File Number: IR98-045

PRELIMINARY APPLICATION.

IR98-045 Entitlements to develop a 1-story, 7,000 sqft. retail building on a .52 vacant acre lot in the Shopping Center Planned Unit Development (SC-PUD) zone within the Natomas Garden PUD in the South Natomas Community Plan Area. (D1) APN: 250-0010-087.

FLOOR PLAN

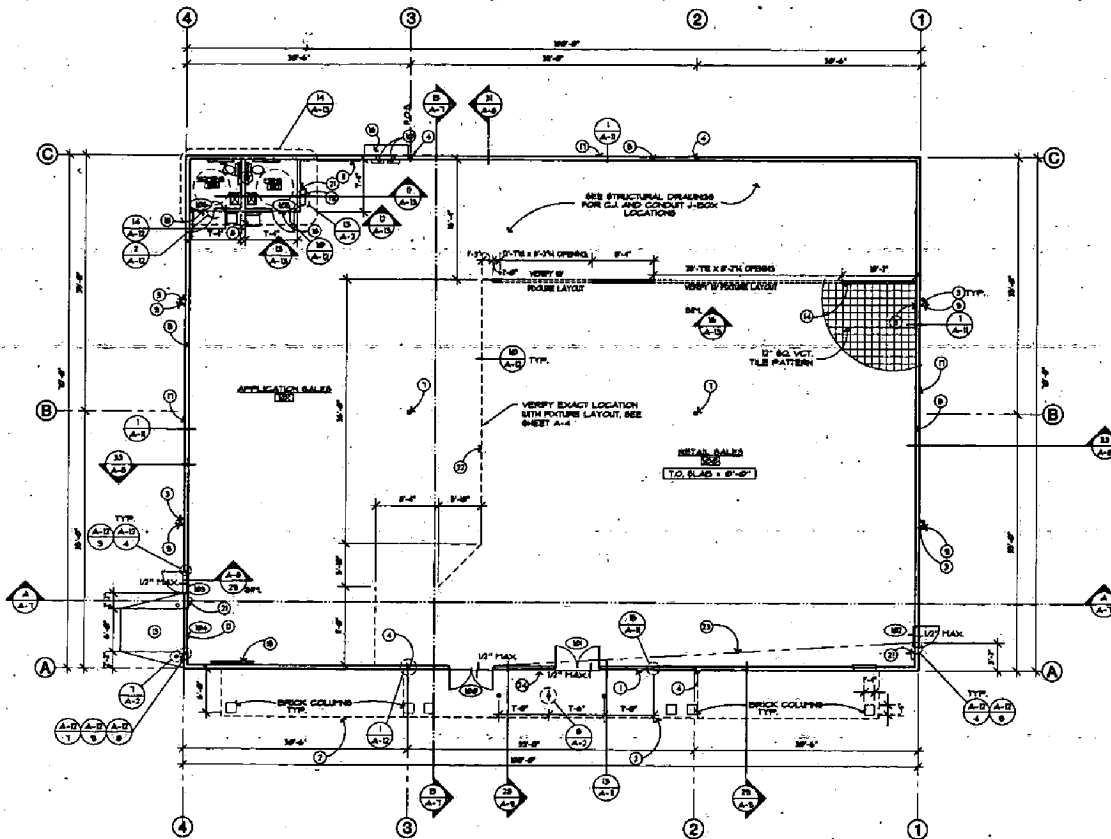
1. fire flow
2. sprinklers
3. KNOX BOX
4. No parking (20' wide) on west side of building
5. wayway from west side of building (employees)
